**ADDENDUM NO. 1**

Project: **STEPHENSON SCHOOL BUILDING & PARKING IMPROVEMENTS**

Owner: **City of Dripping Springs, Texas**

Date: **July 8, 2025**

AI.03

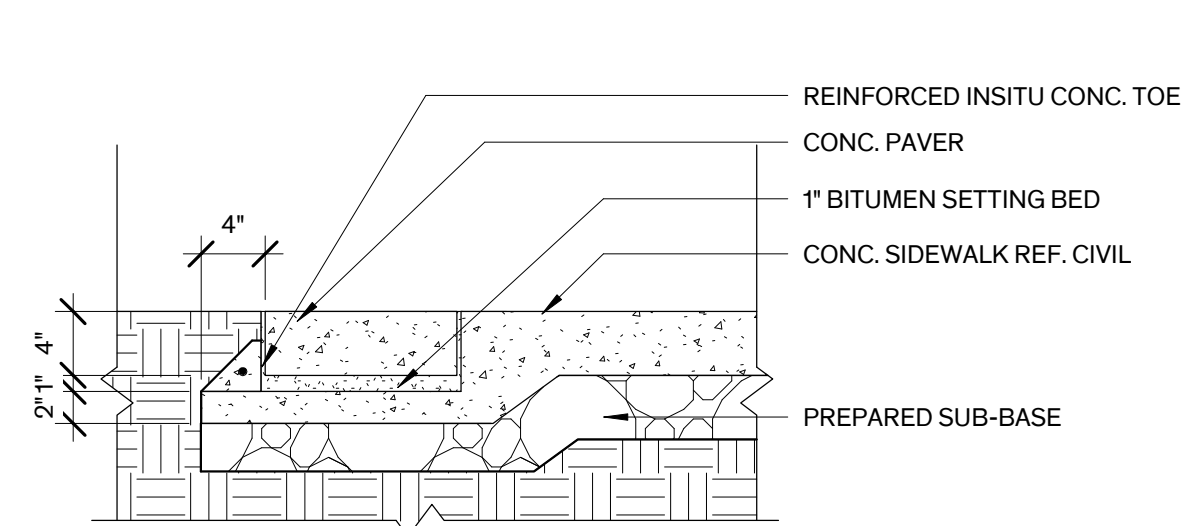
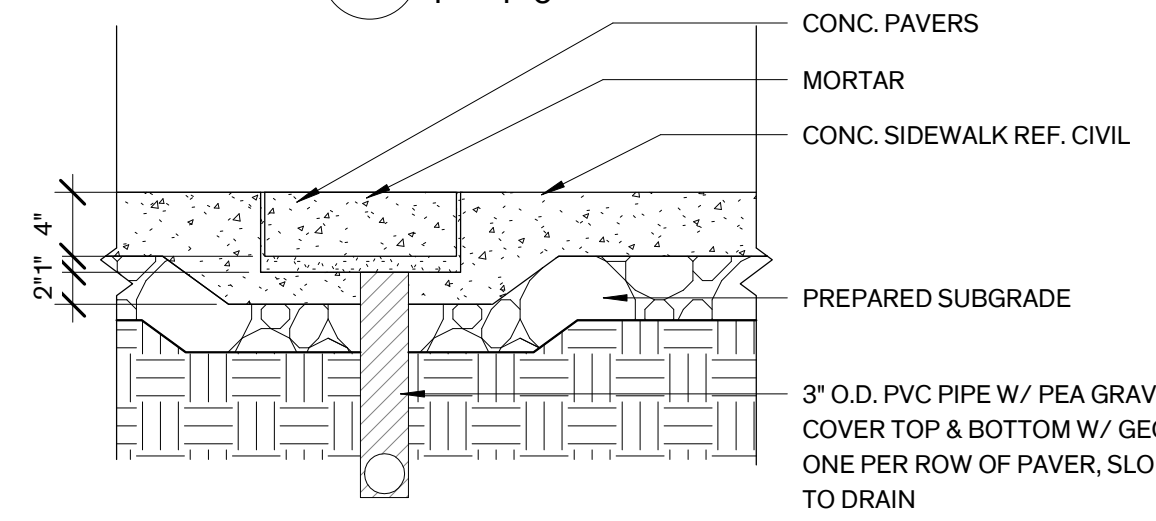
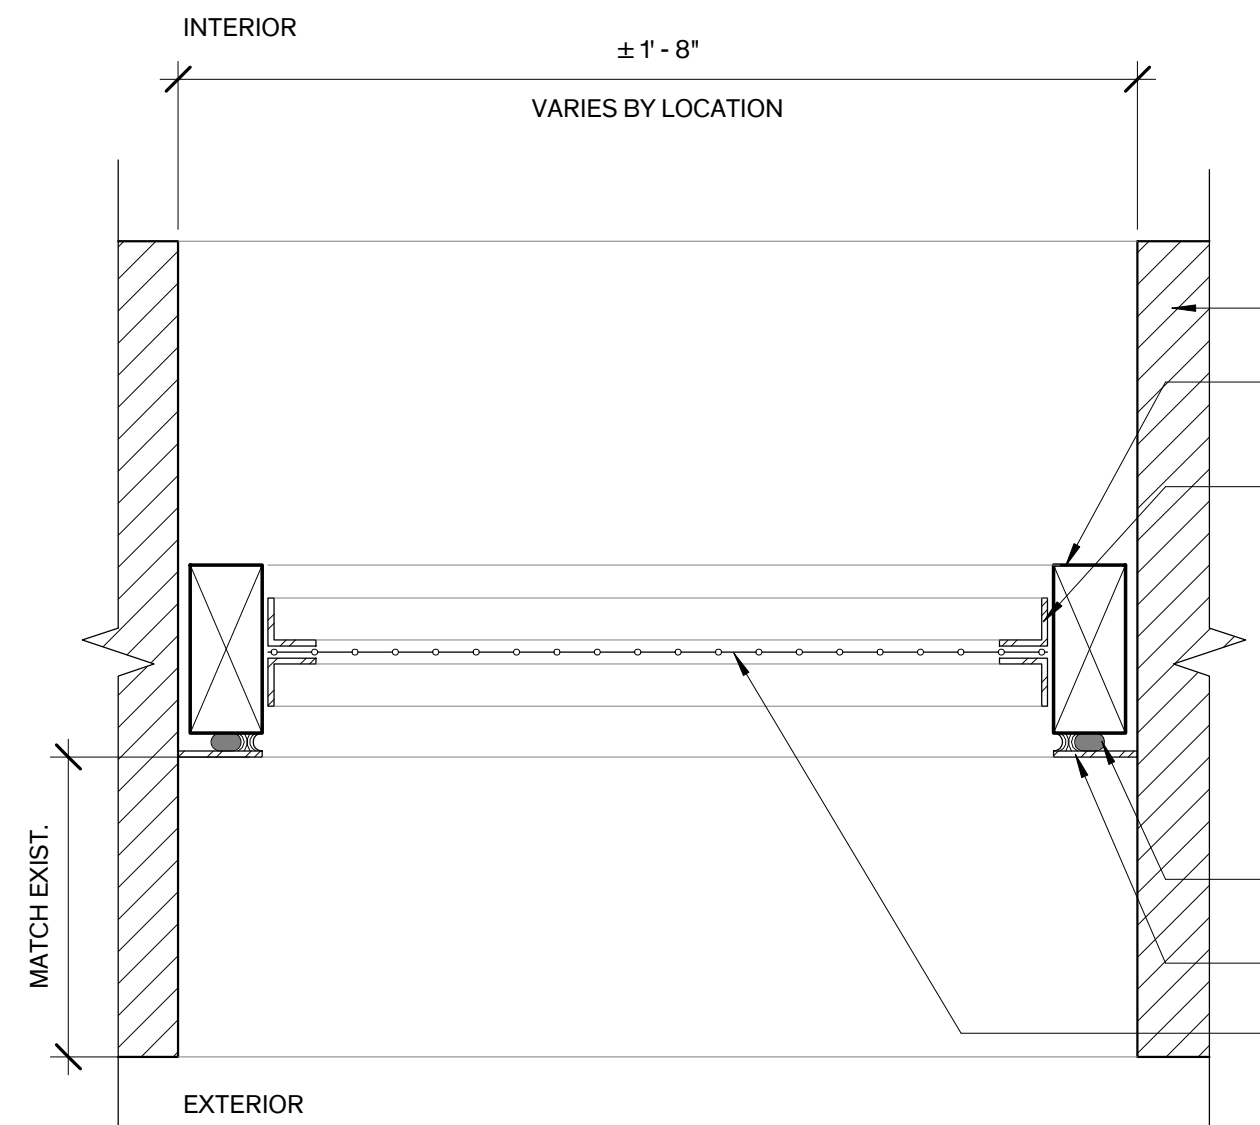
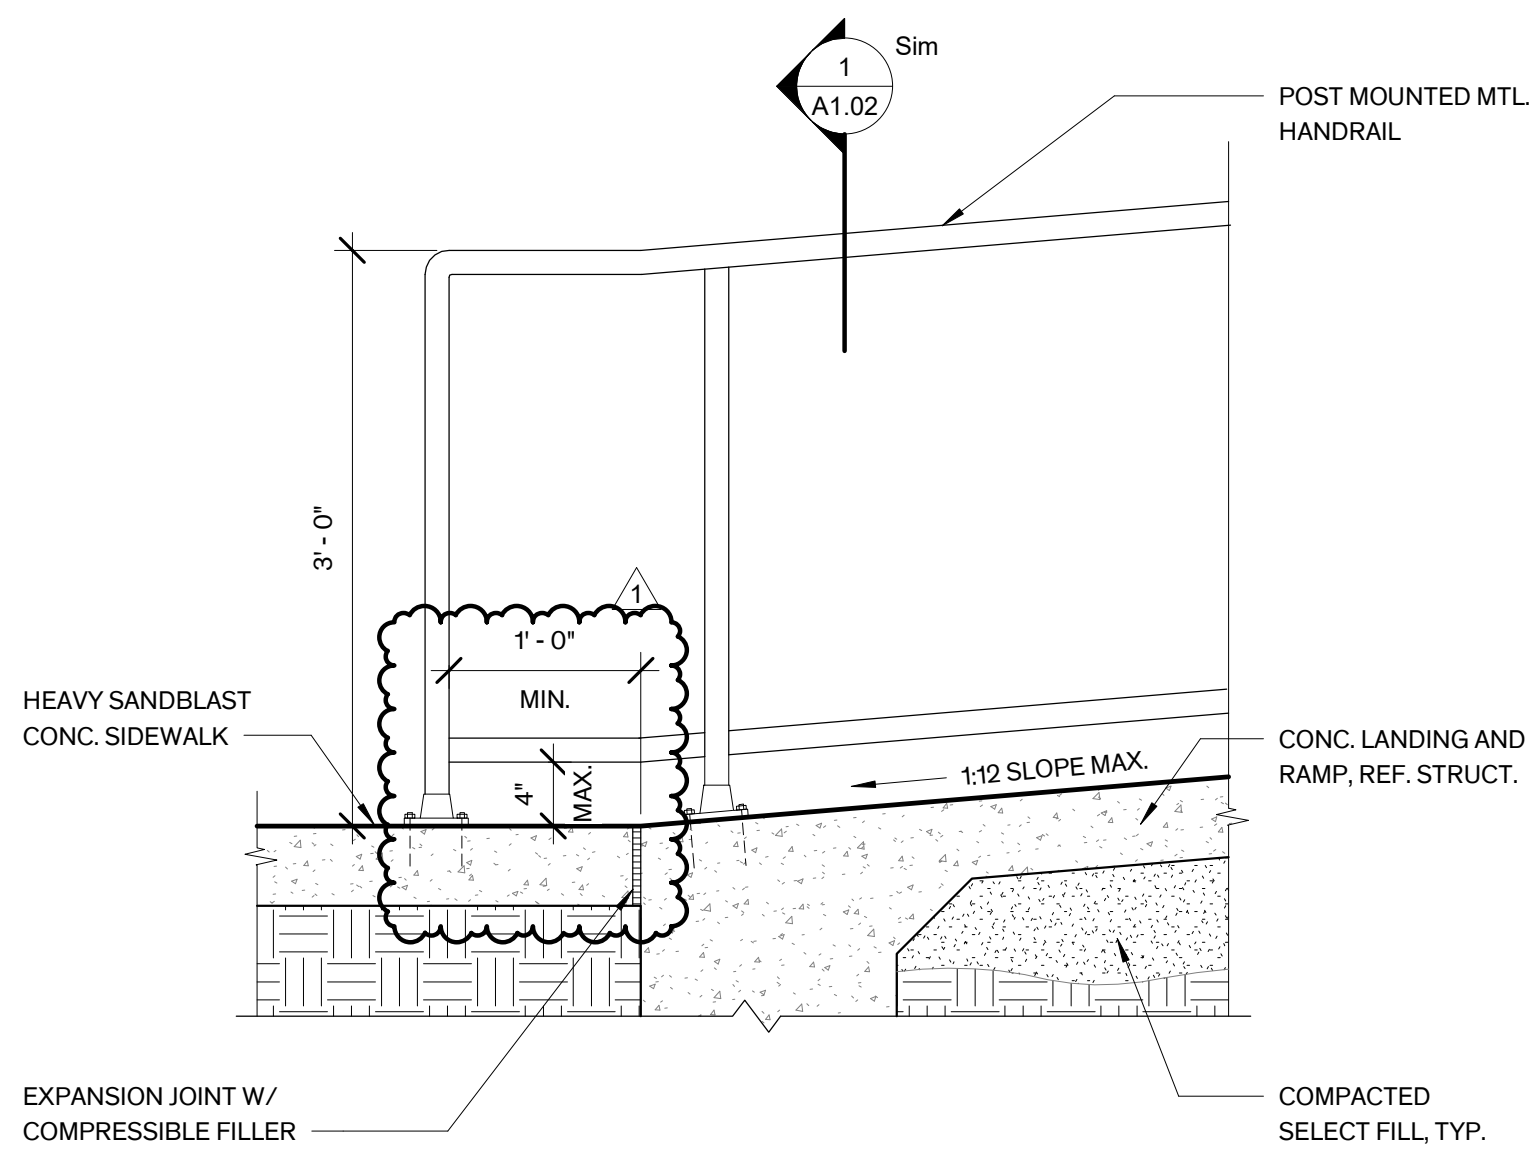
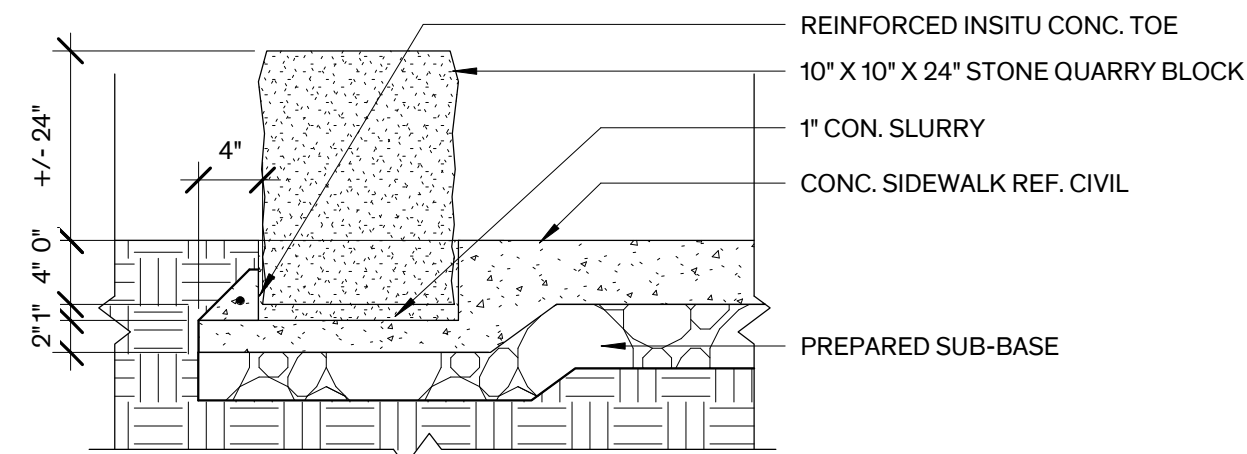
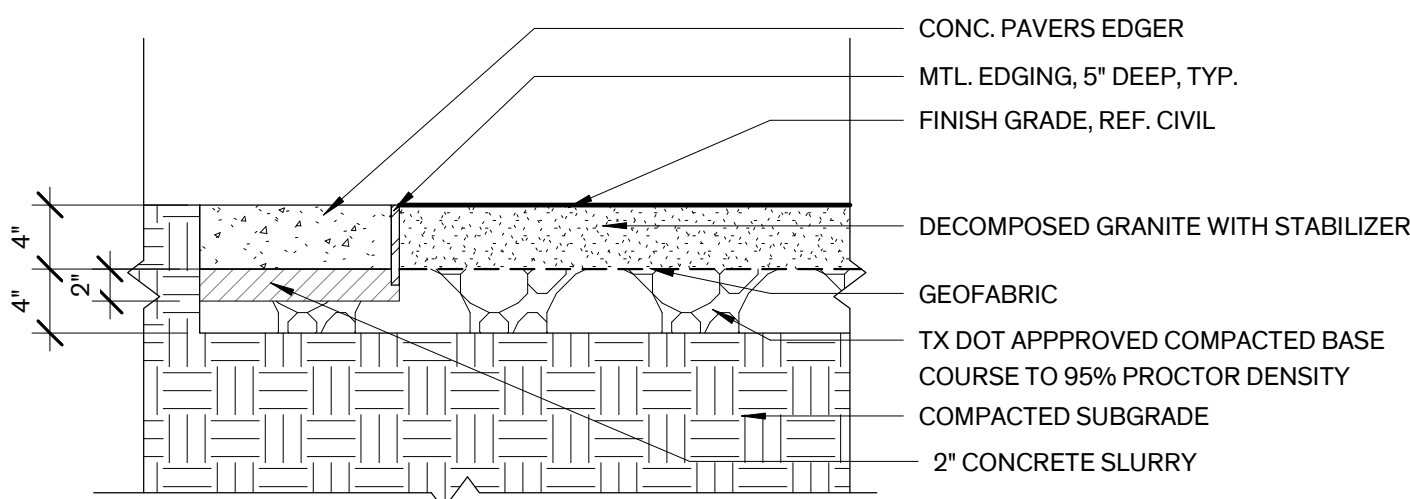
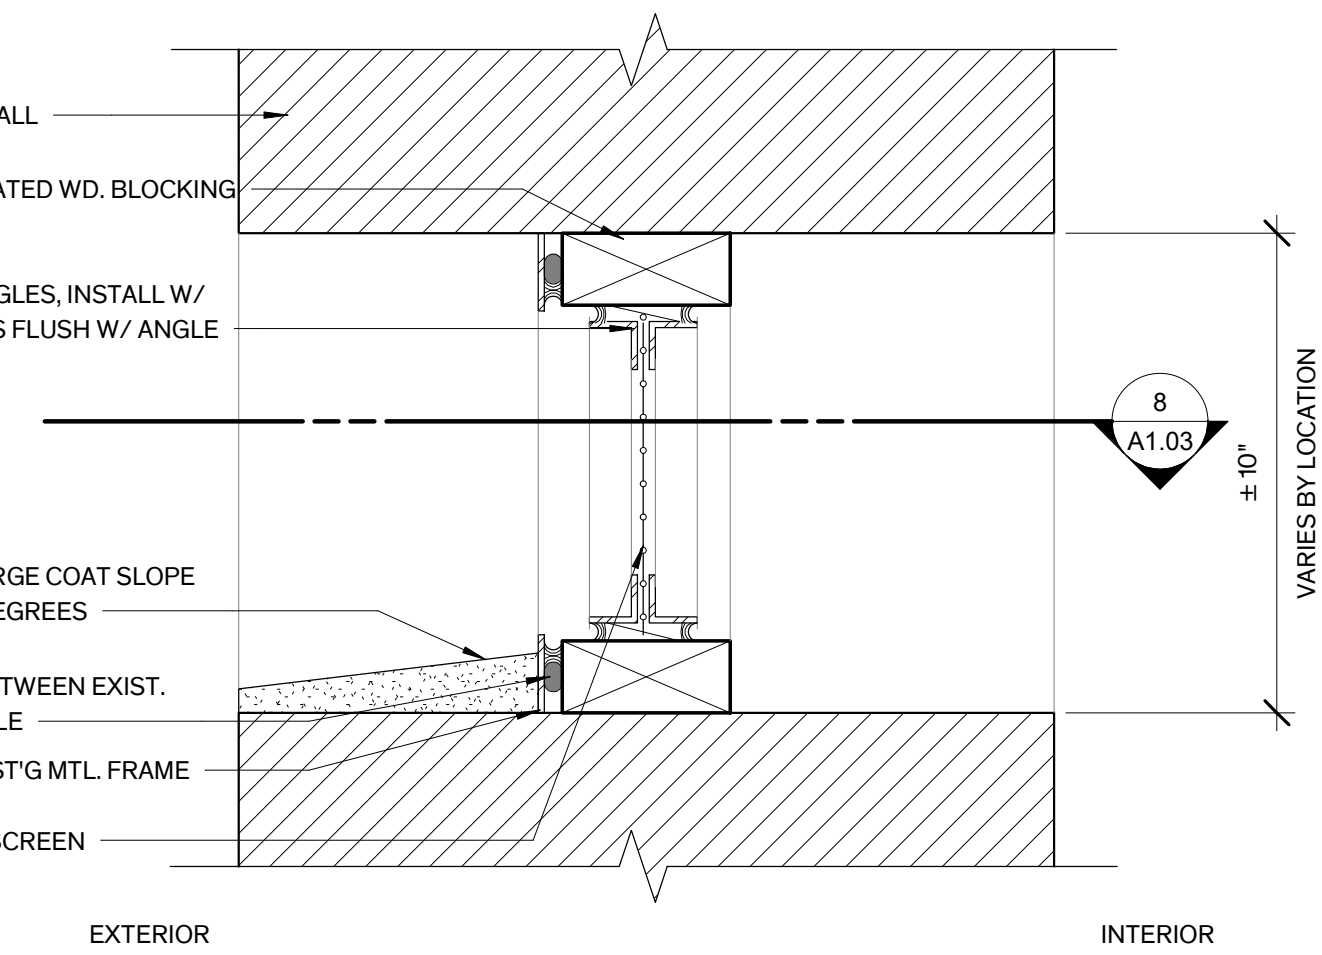
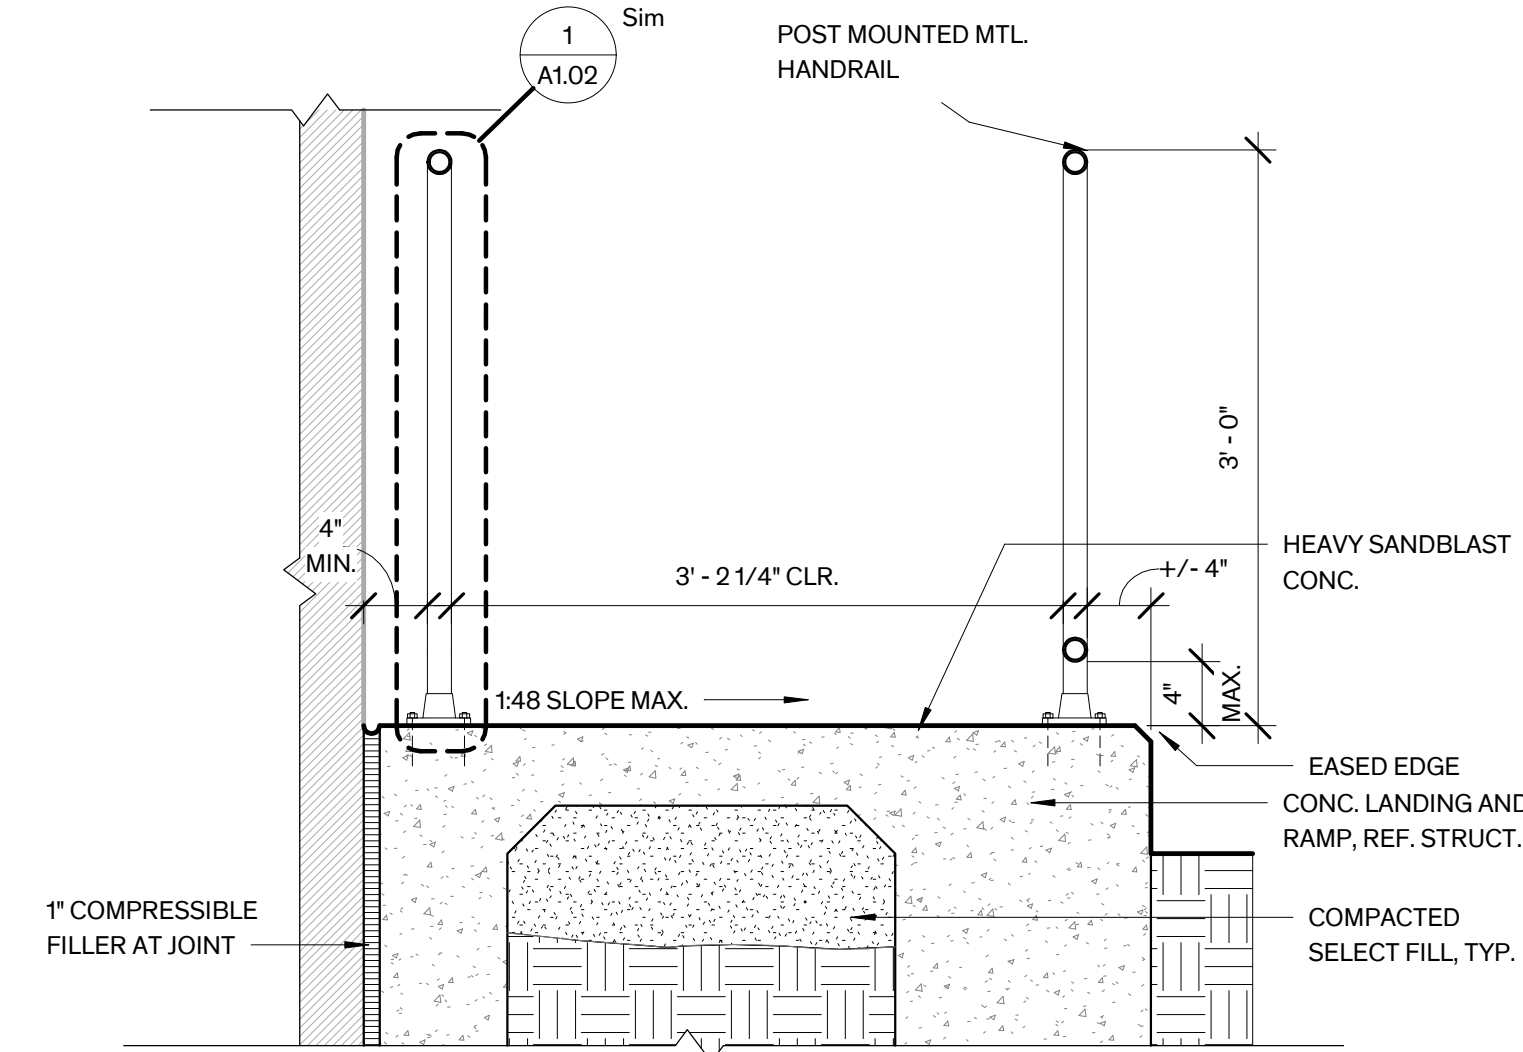
UPDATE – Update handrail dimensioning to show 12 inch extension to back of railing.
